**Preservation Department – Item 3, LPC-25-05585**

**83 Horatio Street – Greenwich Village Historic District**  
**Borough of Manhattan**

NEW YORK CITY LANDMARKS PRESERVATION COMMISSION  
REVISED 10/30/25

83 HORATIO STREET  
NEW YORK, NY, 10014

③ 10/30/25 PROPOSED REAR ELEVATION  
1/8" = 1'-0"

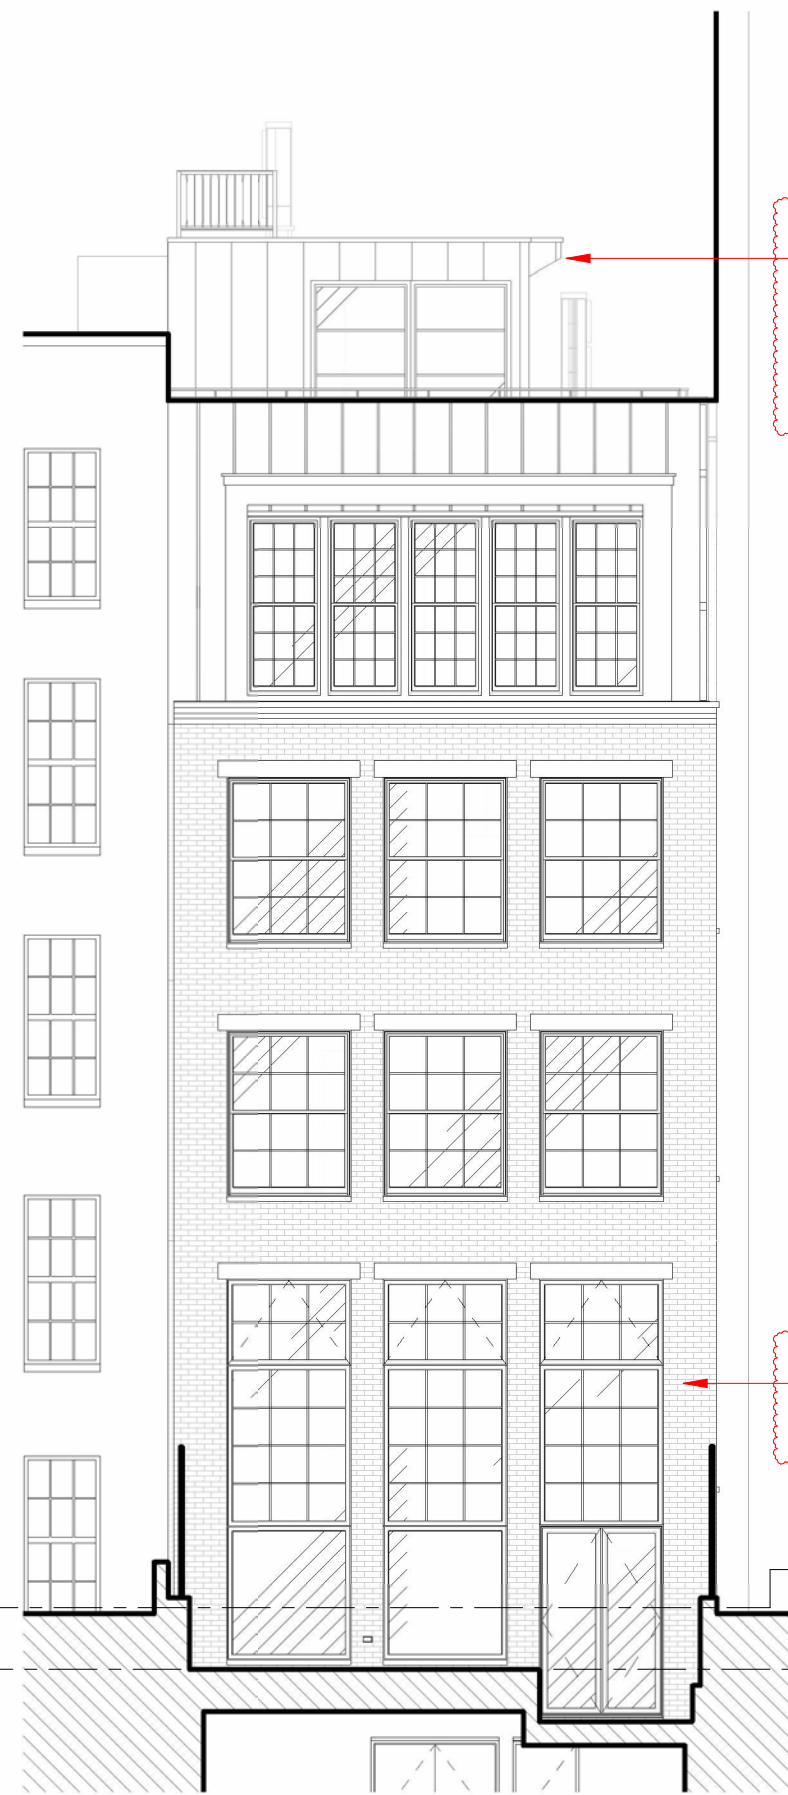
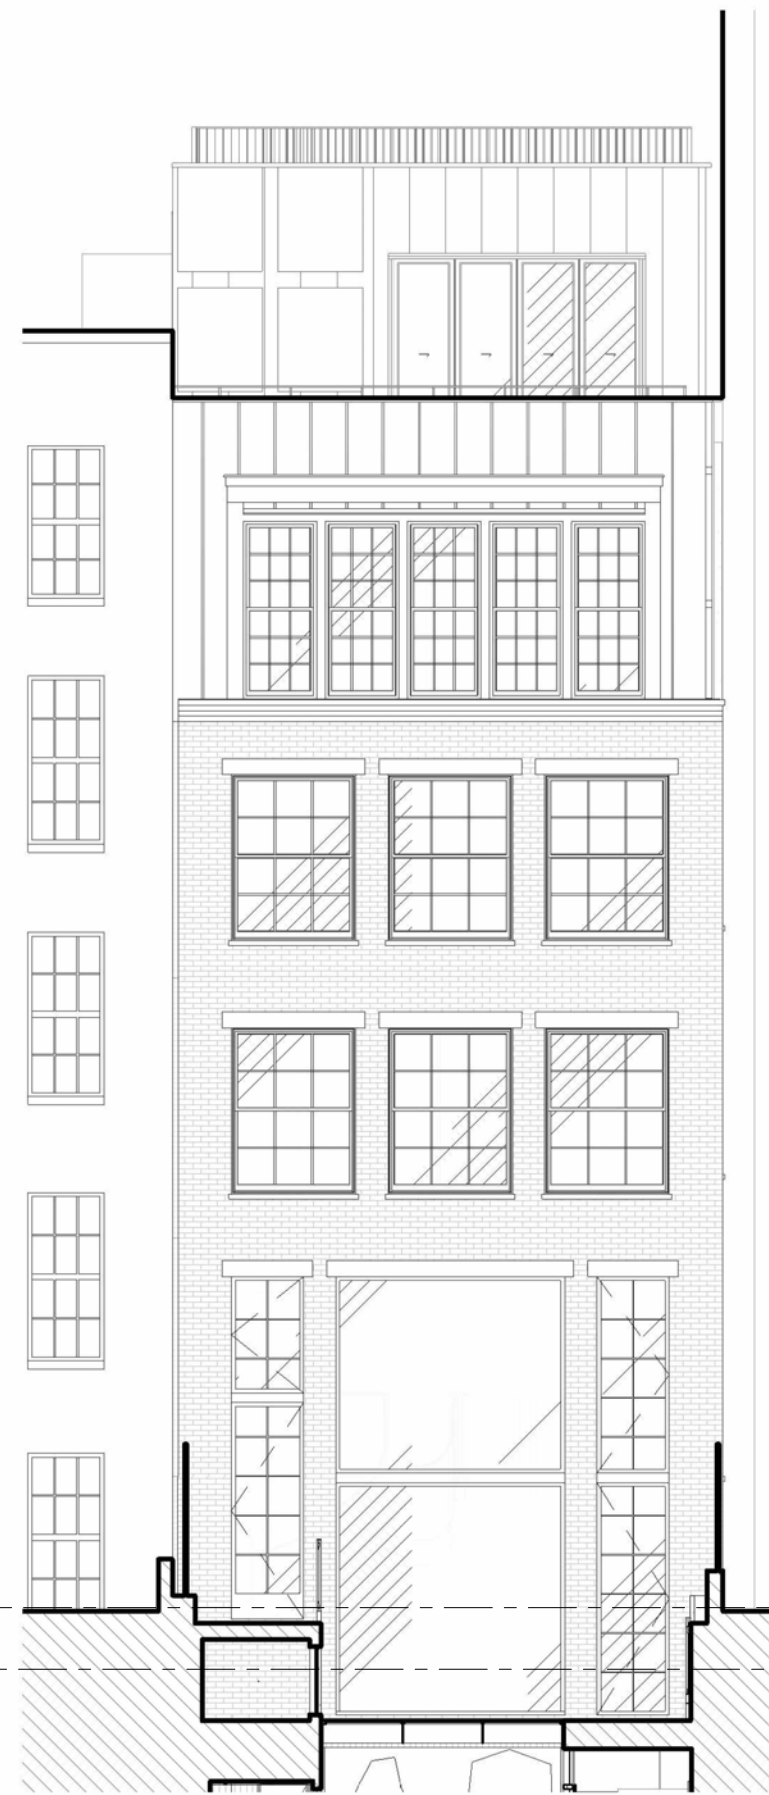
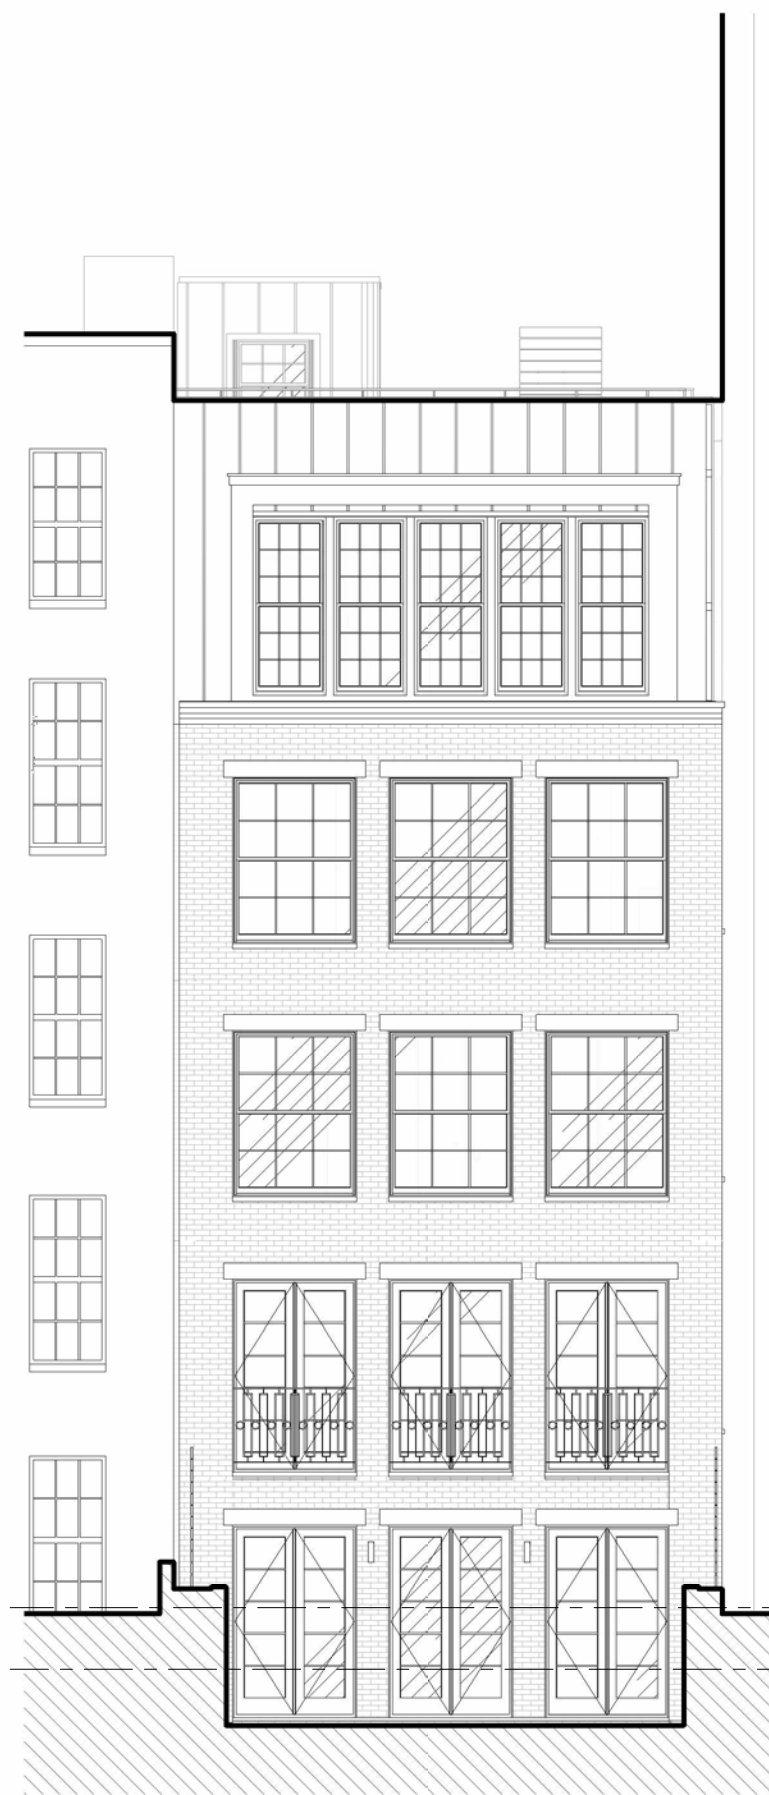
PROPOSED ROOFTOP ADDITION  
METAL PANELS, FLAT SEAM,  
LIGHT GREIGE COLOR; GC TO  
PROVIDE SAMPLES FOR LPC  
REVIEW AND APPROVAL

PROPOSED REAR FACADE  
MODIFICATION
